**General Service Bulletin No. 1**

Subject: Trailing Edge wing drainage

**Service Bulletin: 10,000-1**

**Service Bulletin: 10,000-2**

Detail of drain hole locations (view looking up at bottom side of wing)

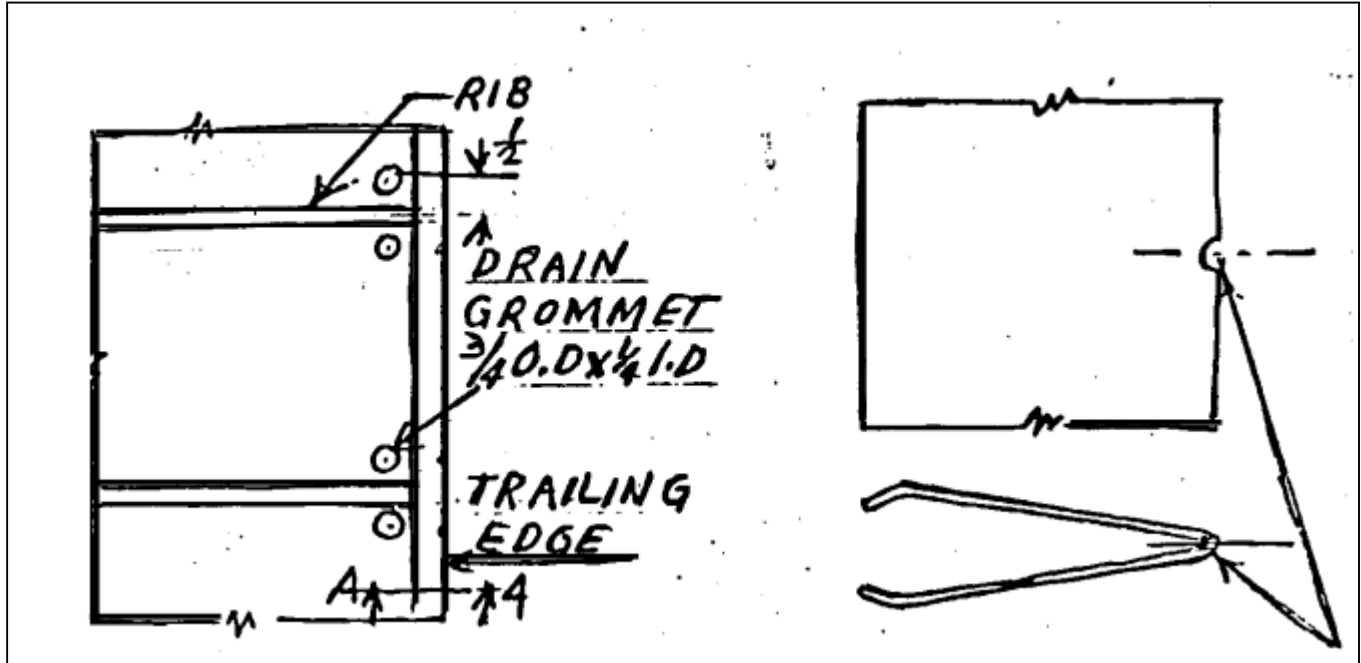
2. Additional drain holes and grommets should be located in the trailing edge portion of the wing, including the trailing edge portion of the wing in the aileron cut-out region and the aileron itself. In addition to this, 1/8" holes should be drilled through the aluminum trailing edge horizontally in the bend of the trailing edge. Remove any fabric that may be pushed into the hole by the drill. See Sketch below.

Section A-A drill  $\frac{1}{8}$ " hole on each side of rib in trailing edge.

Subject: Fuel Valve Stop bracket installation

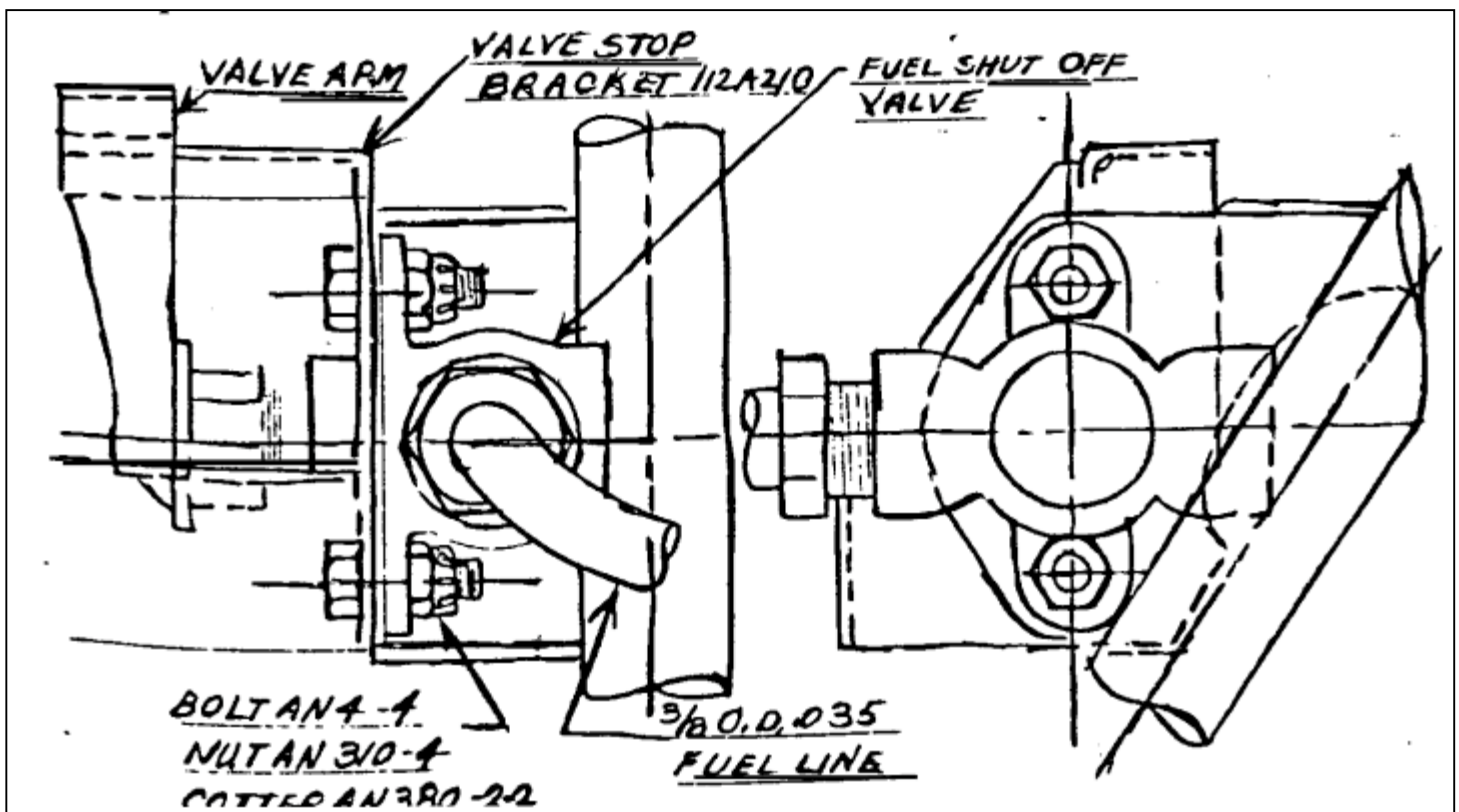
It is not necessary to disconnect any fuel lines to install the bracket (Part 112A210) and this should not be done. Caution should be exercised in installing the bracket, however, so as not to cause fuel system leaks.

The following sketch is self-explanatory in regard to mounting bracket 112A210. It is necessary, however, to disconnect the fuel valve actuating handle, valve arm and valve retaining bolts to mount bracket. These parts are readily accessible by removing the right hand side panel kick pad. Be certain to properly safety all parts before replacing the kick pad.

Subject: Fuel valve stop bracket installation

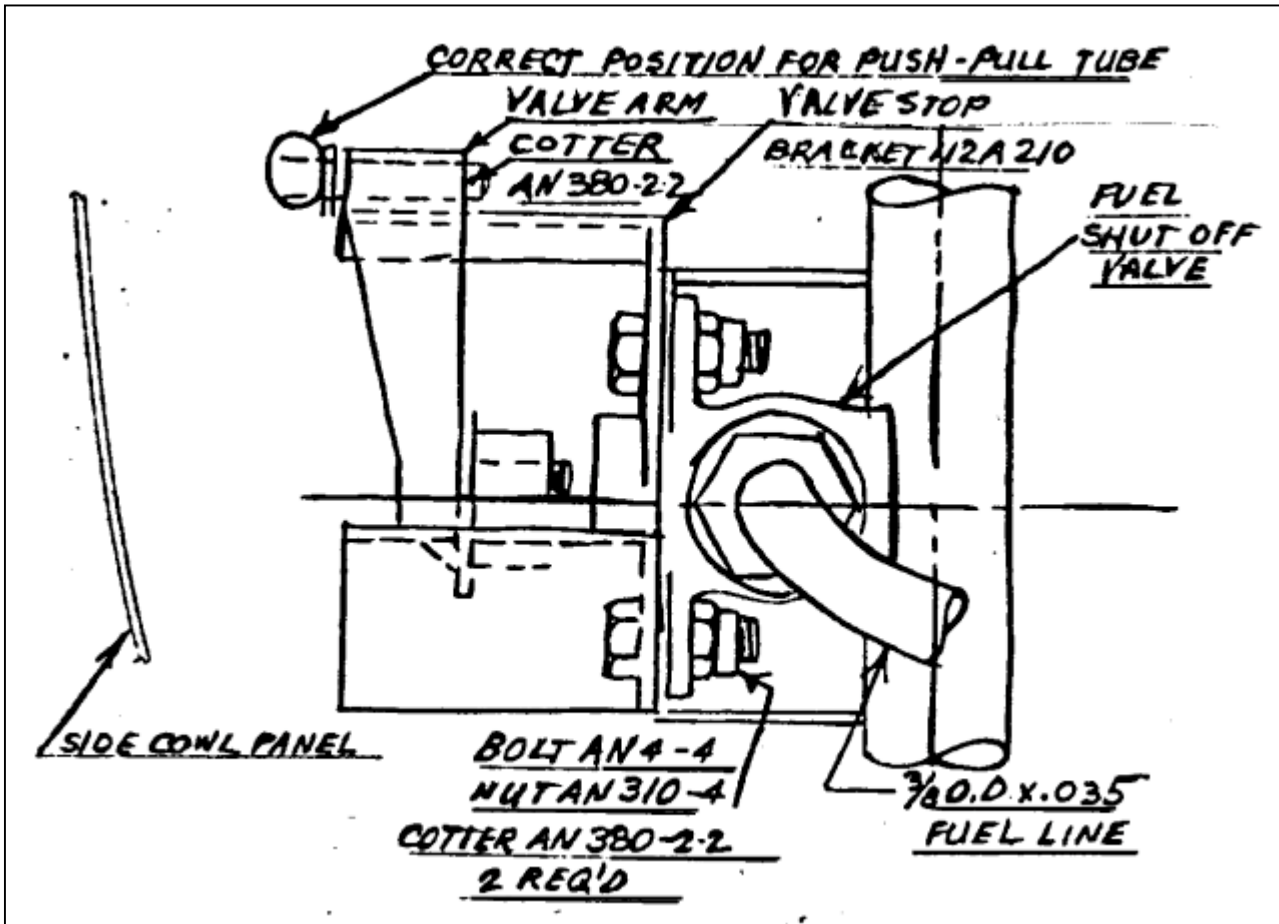
2. In one case the fuel valve actuating lever was incorrectly installed, which did not permit the valve to be opened the full amount due to interference between the valve actuating handle and the new type stop bracket. This interference was due to the valve actuating (push-pull) handle being incorrectly installed. In order to function properly without interference, it is necessary for the push-pull tube to be inserted toward the fuel valve from the region between the valve and cowling. The sketch below will indicate the desired position for the push-pull tube.

3. It is suggested that your installation be checked to make certain that the push-pull tube is correctly installed in your airplane.

Subject: Carburetor heat valve control installation

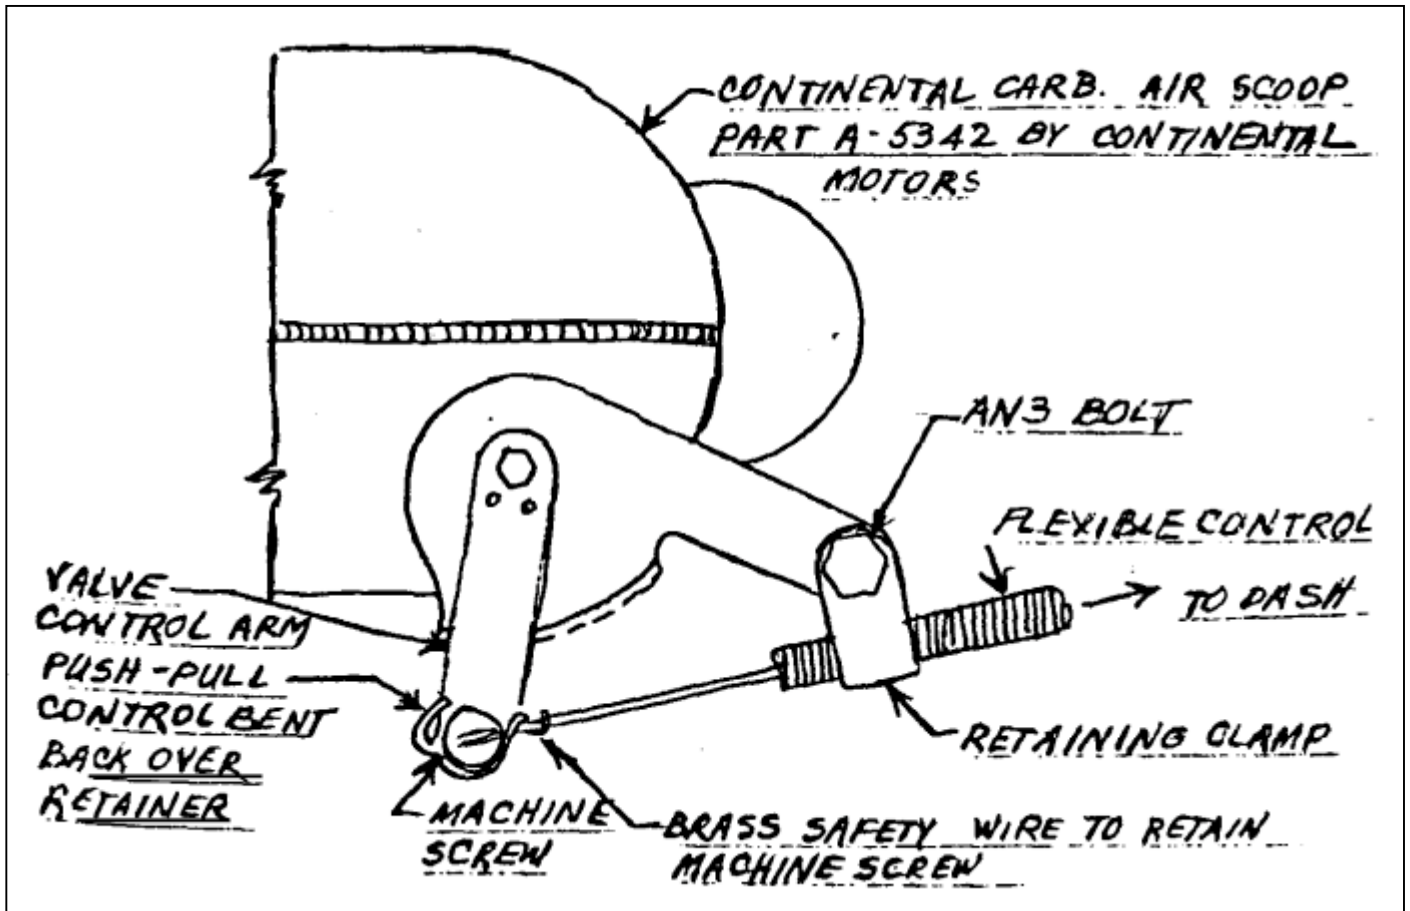
1. This bulletin is being promulgated to assist you in maintaining the airworthiness of your airplane. It is suggested that the attachment of the flexible control to the carburetor heat valve actuating arm be checked for conformity to the sketch below.

2. In the event that the attachment of the flexible casing is not in conformity to the sketch below, it should be altered to conform before again using your airplane as the possibility of it becoming loose in flight so that the heat valve could not be operated may exist.

Fig. 1

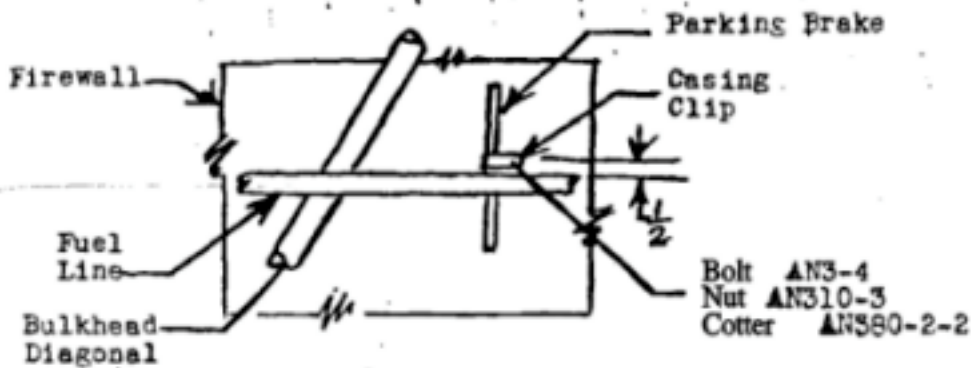
2. On the aft side of the firewall the parking brake bowden casing passes at right angles to the 3/8 O.D. fuel line and passes between the firewall and the fuel line. There is a space between the firewall and the fuel line of approx. 7/8" at this point. In order to prevent the semi-loose bowden casing from vibrating against the fuel line and eventually wearing it through, it is recommended that a clip (Note figure 1) be placed around the bowden casing, retaining it firmly to the firewall at a point approx. 1/2" above the fuel line. This clip should be bolted through the firewall and safetied in place. This will prevent the bowden casing from wearing the fuel line at this point. Clips may be readily made by using .135 or .049 steel or even .051 aluminum sheet bent to the proper shape and then bolted in place. However, if desired, clips of the proper type are available upon request from Rearwin Aircraft & Engines, Inc.

Fig. 2

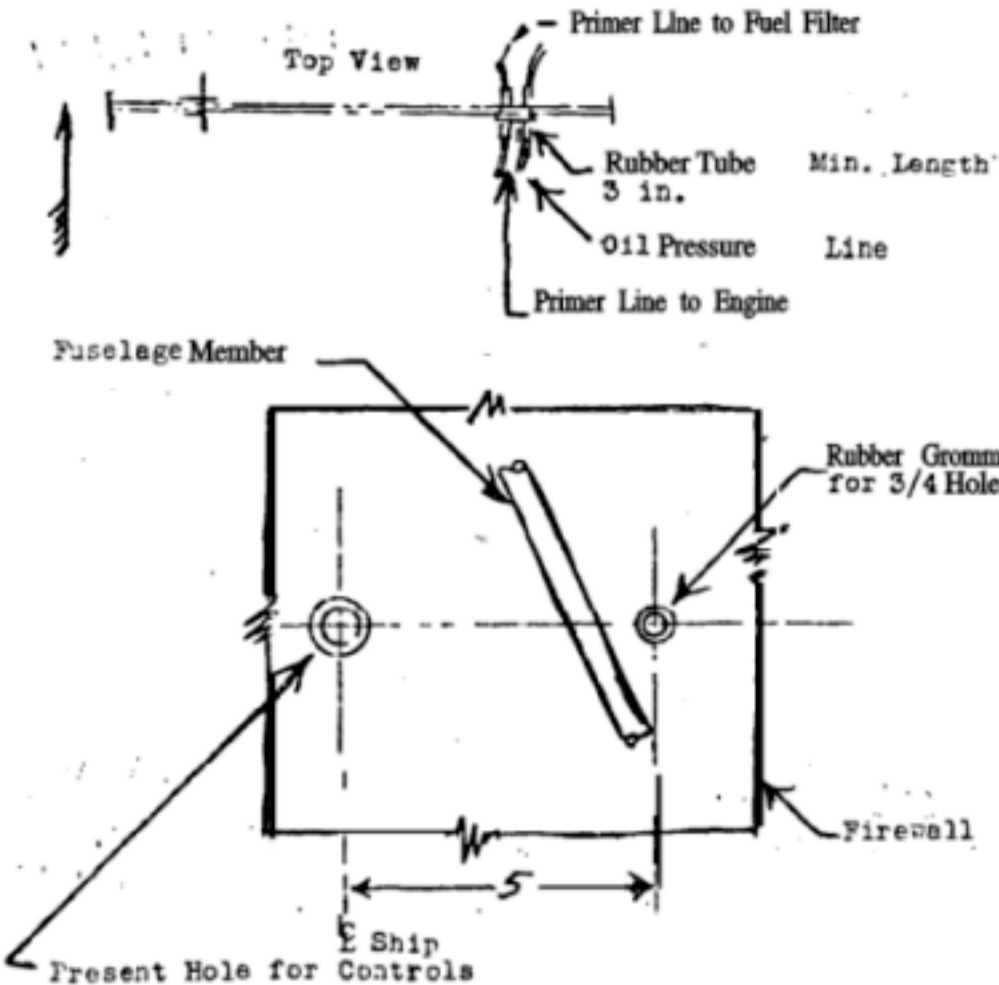
3. On the subject airplanes the primer line from the fuel filter to the primer and the line from the primer to the engine, as well as the oil pressure line, pass through a firewall opening through which ignition wires; temperature casing, and flexible engine controls pass. In view Of the possibility of these units wearing through the primer and oil pressure lines, it is recommended that an additional hole be placed in the firewall approx. 5" to the right of the present hole, which is centrally located, and at the same height vertically. The hole should be 3/4" in diameter. A standard rubber or neoprene grommet is to be placed in this hole to protect the primer and oil pressure lines, which are to pass through this hole from wearing on the firewall The oil pressure line and the large primer line are to be encased in a rubber tube for a distance about three inches of its length at the point where it passes through the firewall. This tubing is to be cemented in place. (Refer Fig. 2 for further clarification.)

Subject: Control Column Plastic Knobs

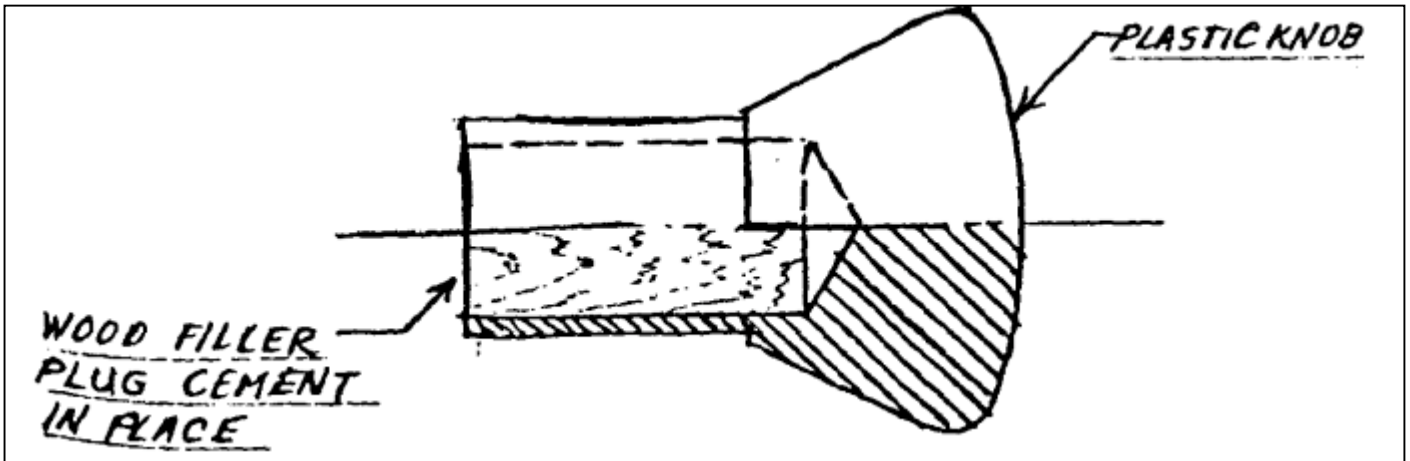
The control column plastic knobs at the present time have a hole drilled on the inside about 1-1/4" deep. This results in weakening the section of the knob at the top of the control column, which in a few cases has resulted, after considerable usage, in the snapping off of the control knob at the critical section. In view of the fact that fractures of this type occur instantly and are not gradual, it is considered that a certain hazard may exist during some maneuvers, such as take-off and landing, if this difficulty is experienced during these maneuvers.

In order to remove the possibility of this occurring, it is recommended that a wood plug be fitted and cemented in place in the hole in the control stick knob. This will add greatly to the strength of the knob at the critical section, It is necessary for the plug to extend the full depth of the hole in order to obtain the desired results, Note the sketch below, After the knob is plugged, it should be re-cemented in the control column, using Plastic Cement.
